APPENDIX R EXEMPTION REQUESTS
TECHNICAL EVALUATION OF DRAFT
SAFETY EVALUATION

POINT BEACH NUCLEAR PLANT, UNITS 1 AND 2

TECHNICAL EVALUATION

DRAFT SAFETY EVALUATION

Figure 5.2-1. Fire Area 1 - Unit 1

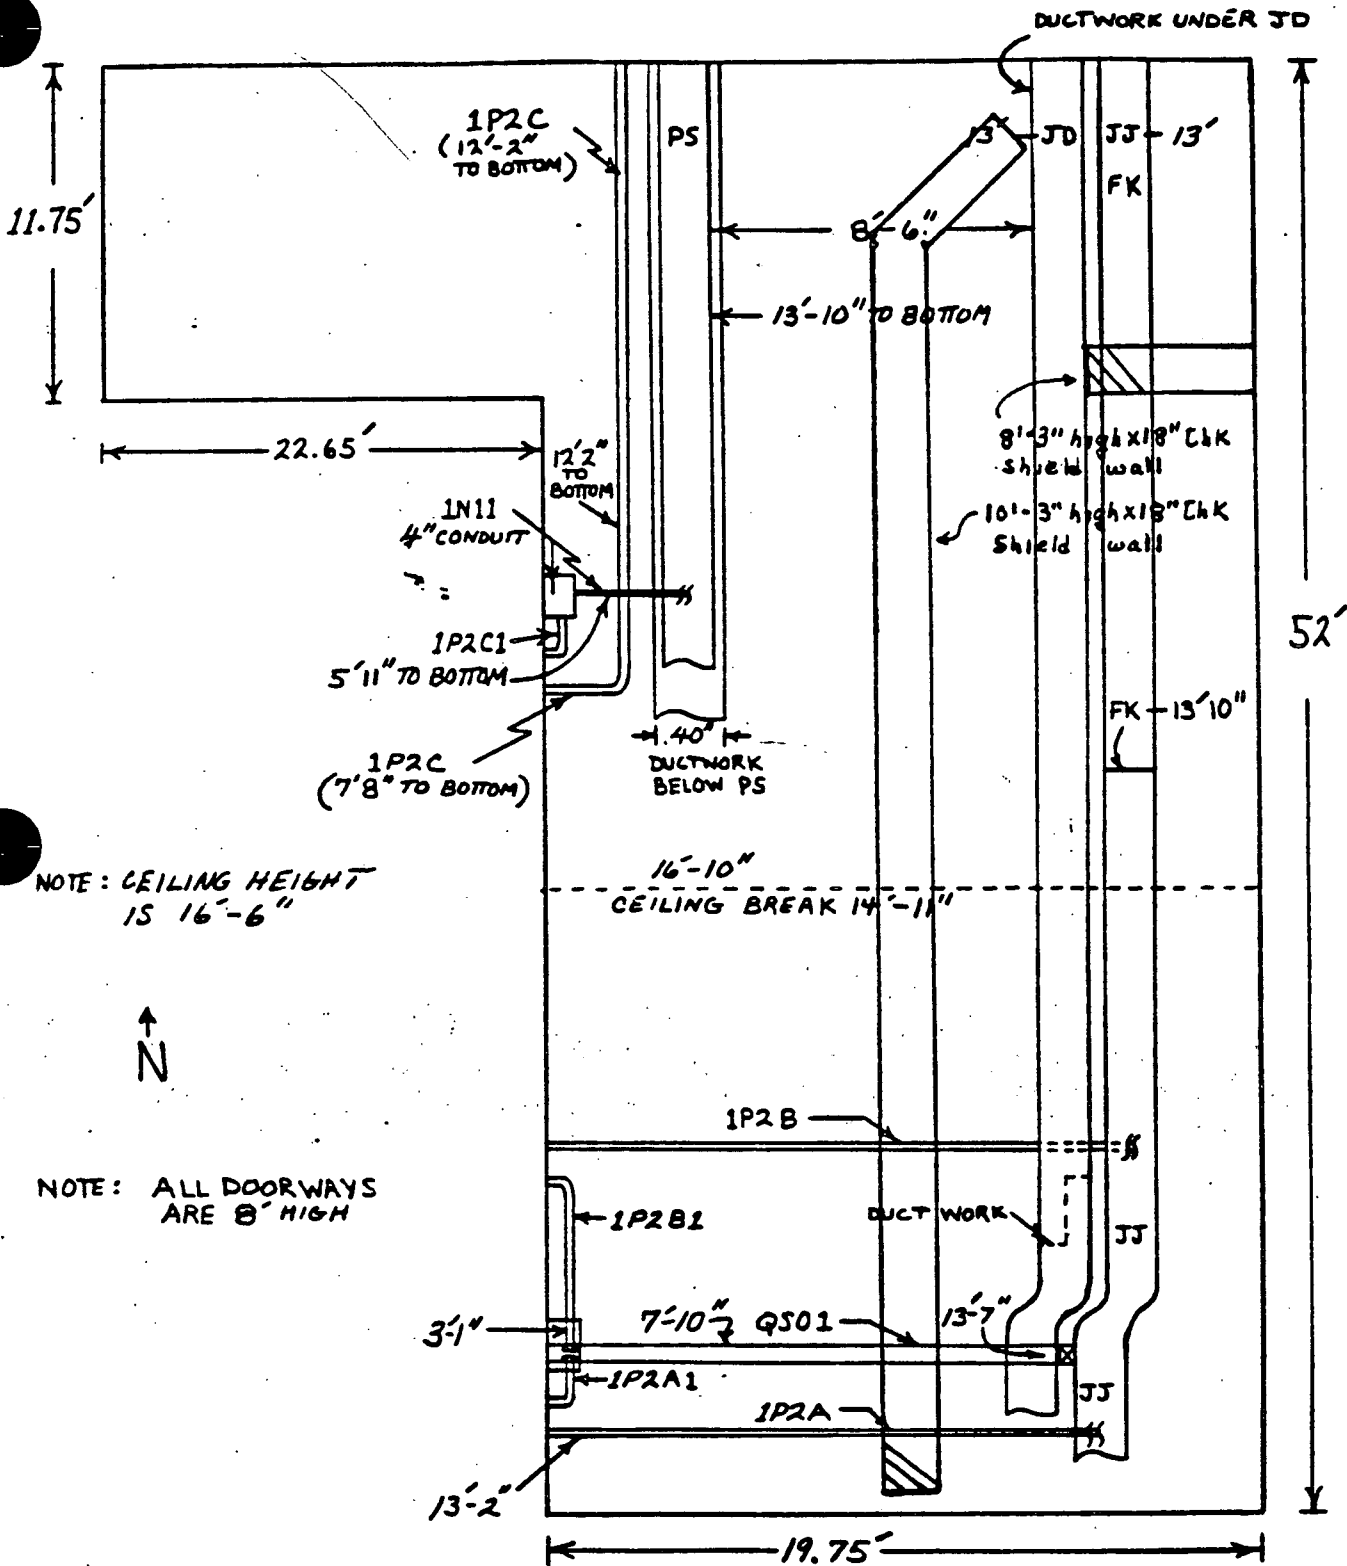
A shield wall has been installed in Fire Zone 1 as part of post-TMI-2 modifications. The location of the shield wall restricts the potential for redundant cable trays to become directly involved in a single flammable liquid spill fire. The shield wall location is shown on the attached marked-up copy of Figure 5.2-1 from the Point Beach analysis.

Figure 5.3-1. Fire Area 2 - Unit 1

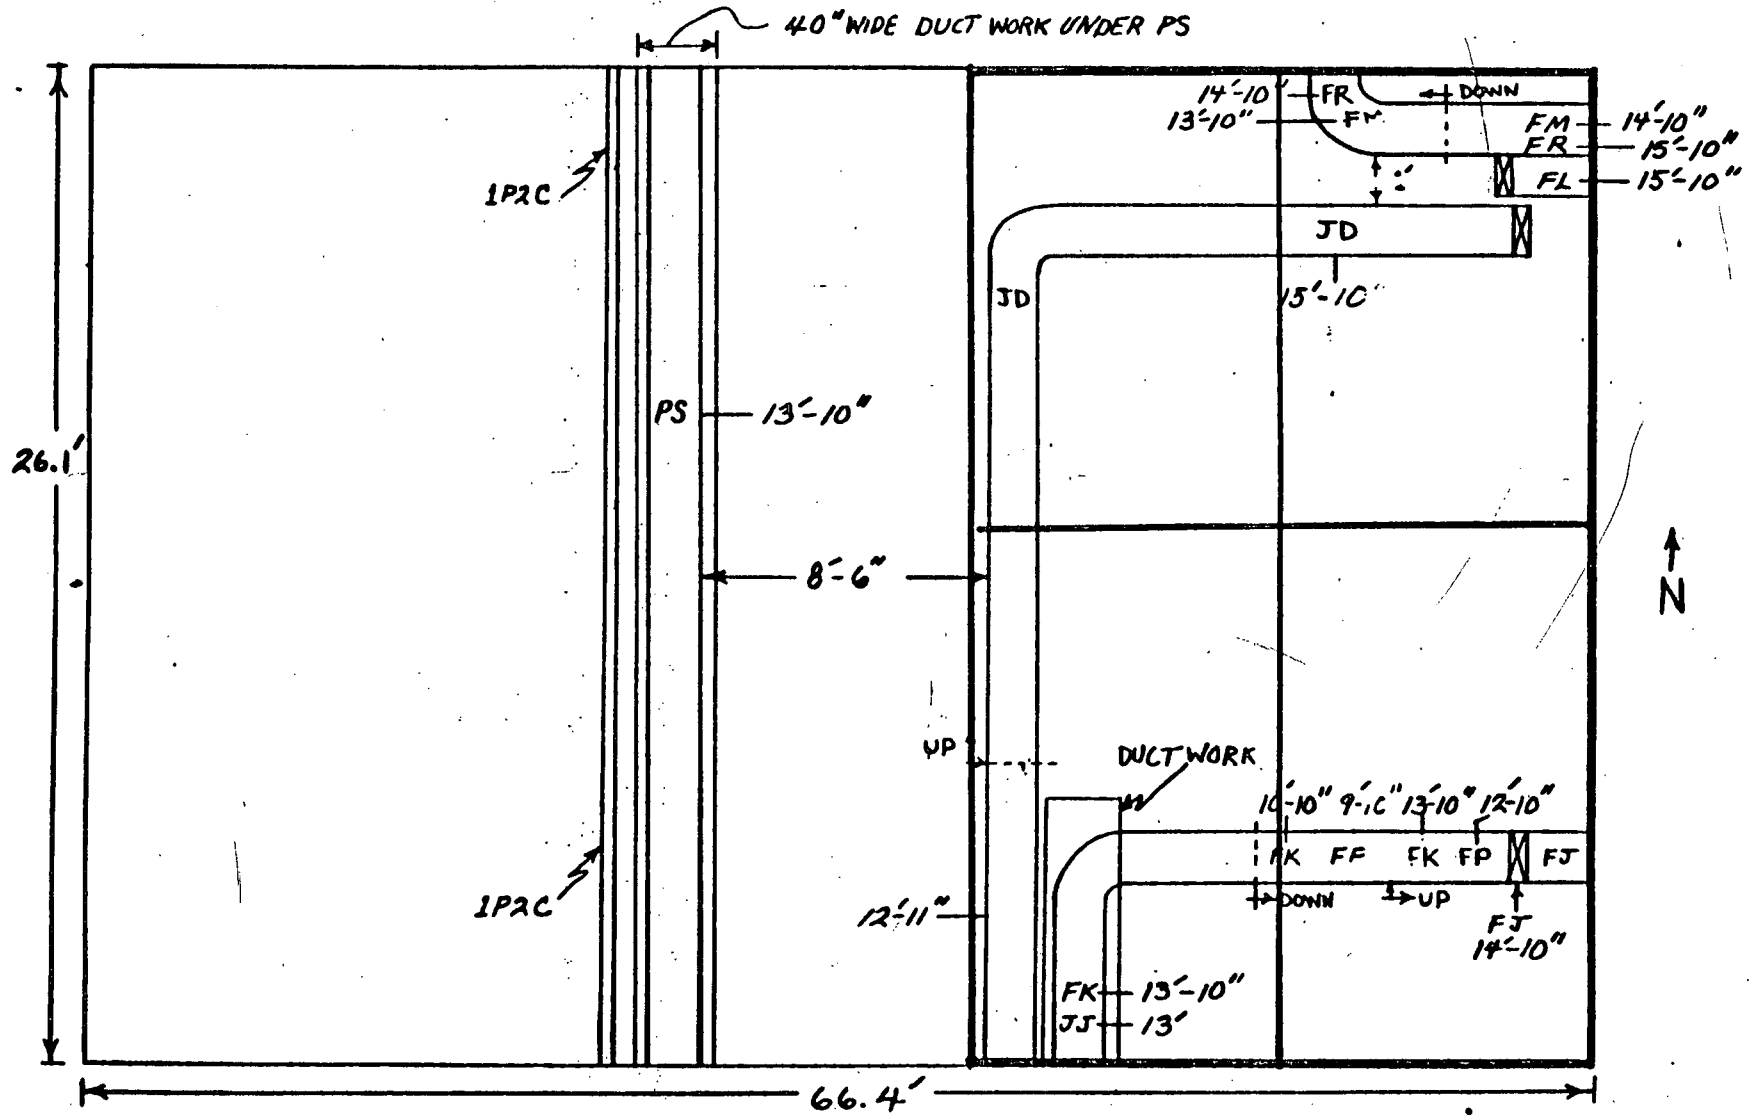
We have reinspected the fire zone and verified that the wet pipe suppression system provides sprinkler protection for all Division "A" circuits and Division "B" circuits with the exception of Tray PS and conduit 1P2C. Even these circuits could be indirectly protected from ceiling hot gas stratification effects by the installed water suppression system. A copy of Figure 5.3-1 marked to show the area of automatic water suppression system protection is attached.

Figure 5.4-2. Fire Area 3 - Unit 2

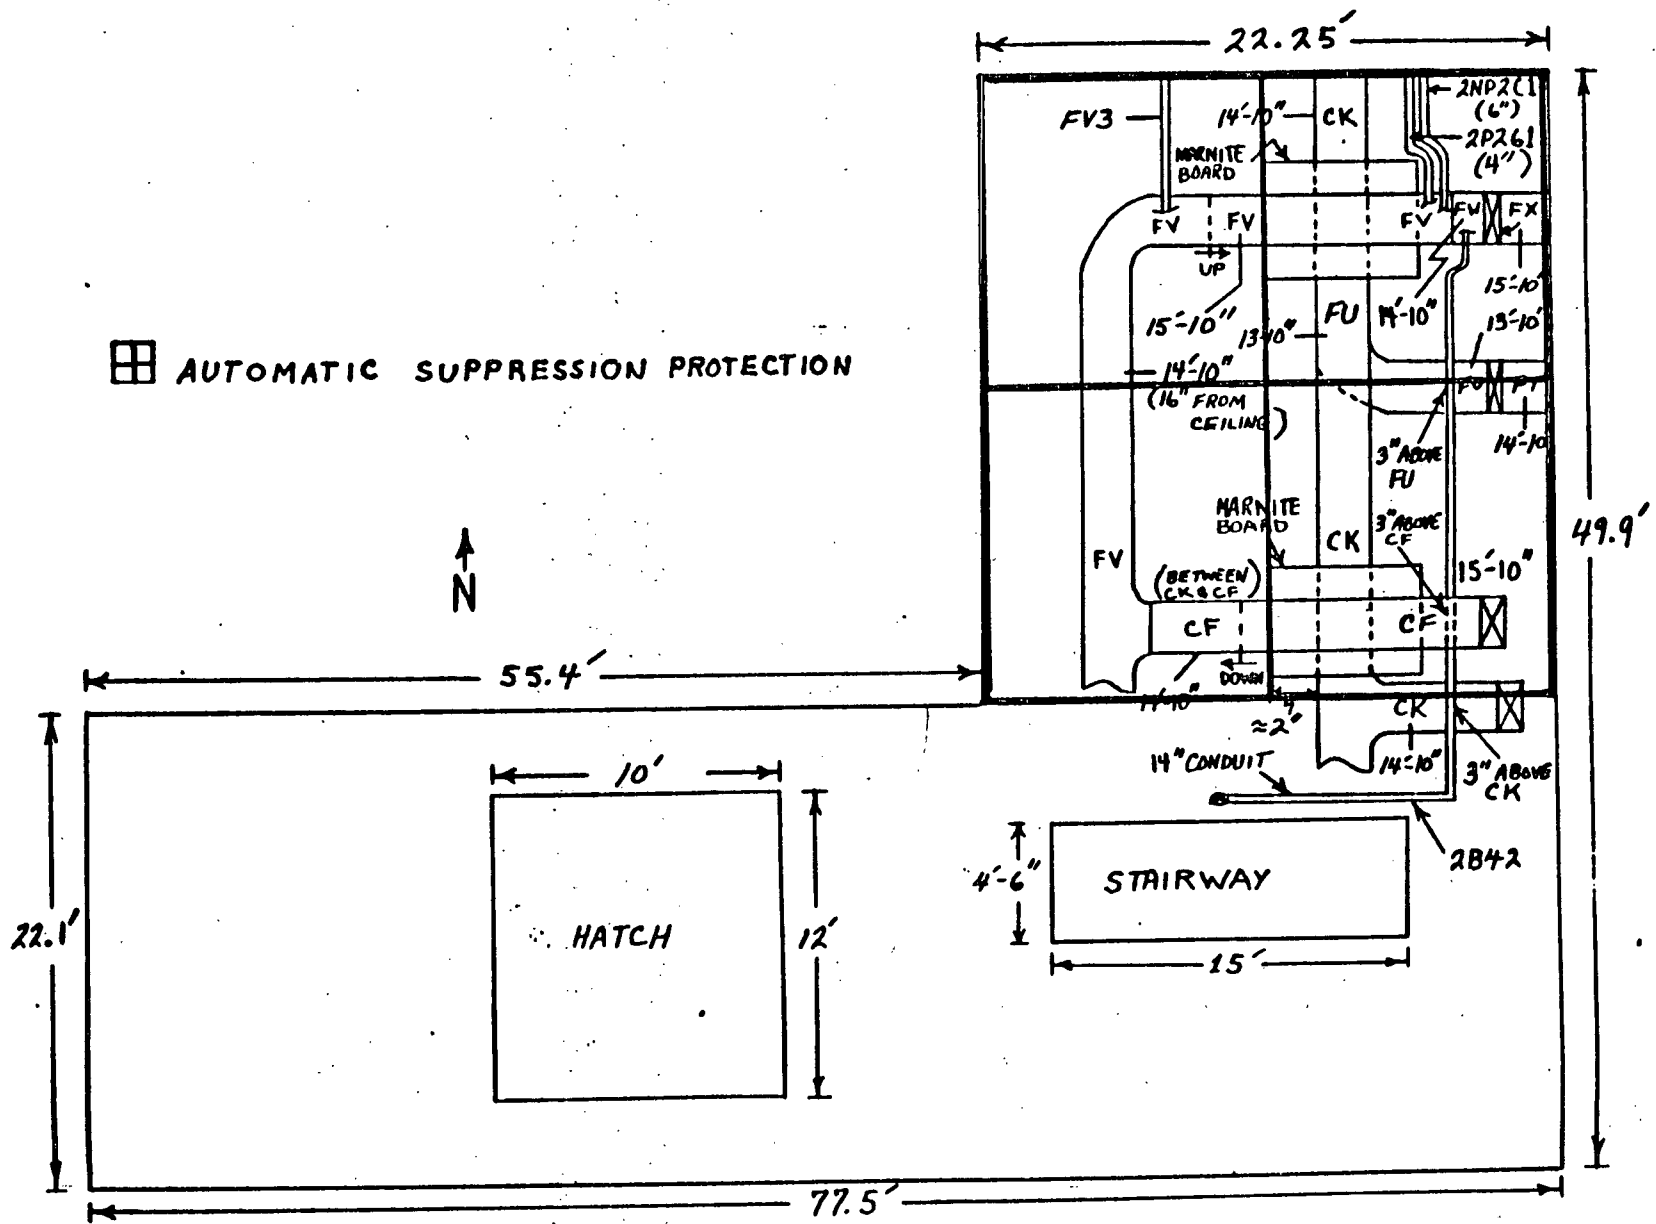
protected from ceiling hot gas stratification effects by the installed local suppression system. A copy of Figure 5.4-2 marked to show the area of automatic water suppression is attached.

Figure 1 Conduction Model for Determining the Effectiveness of Radiation Shields for Panel Components

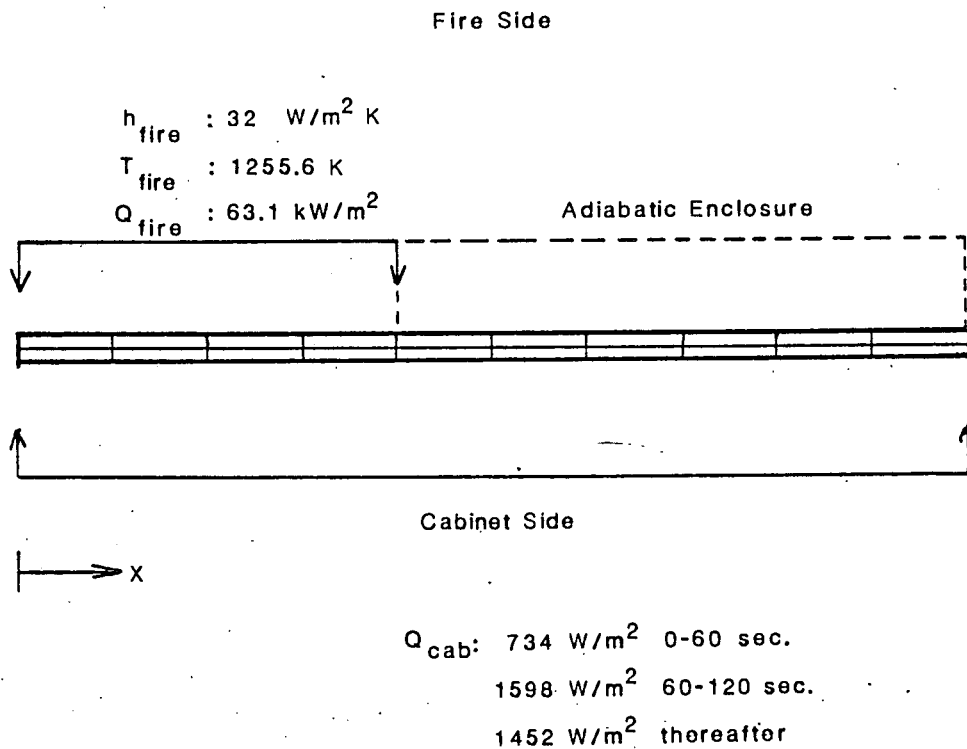
Only conduction along the panel is modeled in this analysis. A short 5-inch long section of panel is modeled using the MERLIN finite element program. The model layout is shown in Figure 1. On the fire side of the panel, the model is exposed to the fire over a 2-inch span. The boundary conditions for this surface include 63.1 kW/m^2 radiation from the fire, convection from the fire using a heat transfer coefficient of $32 \text{ W/m}^2 \text{ }^\circ\text{K}$ and a flame temperature of 1255.6°K , and re-radiation from the surface. The surface emissivity is assumed to be 0.95. The remainder of the fire side surface is assumed to be protected by the enclosure. This surface is assumed to be adiabatic. The cabinet side of the panel is assumed to be "looking" at the air temperature generated by the HOTBOX simulation from the previous section. These temperatures are treated as a radiation boundary condition. The fire period is broken into two pieces with an average cabinet air temperature and incident radiation defined to be:
